Access Compliance Report

Public Rights-of-Way

(Curb Ramps)

Intersection ID: 10019902	Main Street: ARCO_CORPORATE_DR	Cross Street: N/A	Location: NE
ADA ID: 3BA492D321E5	Ramp Type: PerpDiag	Initial Pass/Fail: Fail	Overall Compliance: No
Codes/Mitigation Info/Possible Solution		Field Measurements/Component Compliance	
Severity Score: 22.5

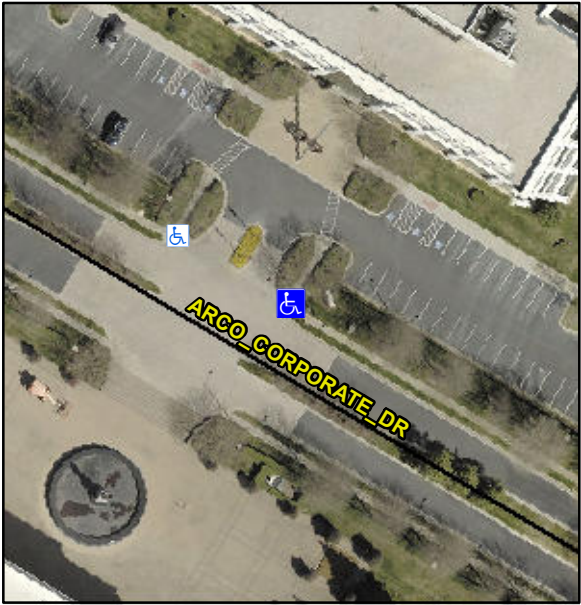
Possible Solutions:	Compliance	Description	Data	Compliance	Description	Data
	Remove & Replace Curb Ramp With Two New Directional Ramps or Equivalent.	N/A	Ramp Length (in)	50.0	No	Ramp Slope (%)	10.3
		No	Ramp Width (in)	40.5	No	Ramp XSlope (%)	3.9
		N/A	Flare Type LT	N/A	N/A	Flare Type RT	N/A
		N/A	Flare Slope LT (%)	N/A	N/A	Flare Slope RT (%)	N/A
		N/A	Flare Traversable LT?	N/A	N/A	Flare Traversable RT?	N/A
		N/A	Landing Length (in)	N/A	N/A	DWS Provided?	N/A
		N/A	Landing Width (in)	N/A	N/A	DWS Contrast?	N/A
		N/A	Landing Slope (%)	N/A	N/A	DWS Length (in)	N/A
		N/A	Landing X Slope (%)	N/A	N/A	DWS Full Width?	N/A
<p>Surveyor Notes:</p> <p>N/A</p> <p>PROW/ADA:</p> <p>R304.5.1, R304.2.2, R304.5.3</p>		N/A	Landing Curb? (Y/N)	N/A	N/A	DWS Offset (in)	N/A
		N/A	Shared Landing?	N/A			
		N/A	Gutter Ponding?	N/A	N/A	Gutter Slope (%)	N/A
		N/A	Gutter Lip Ht (in)	N/A	N/A	Gutter X Slope (%)	N/A
		N/A	Painted X Walk1?	No	N/A	Painted X Walk2?	No
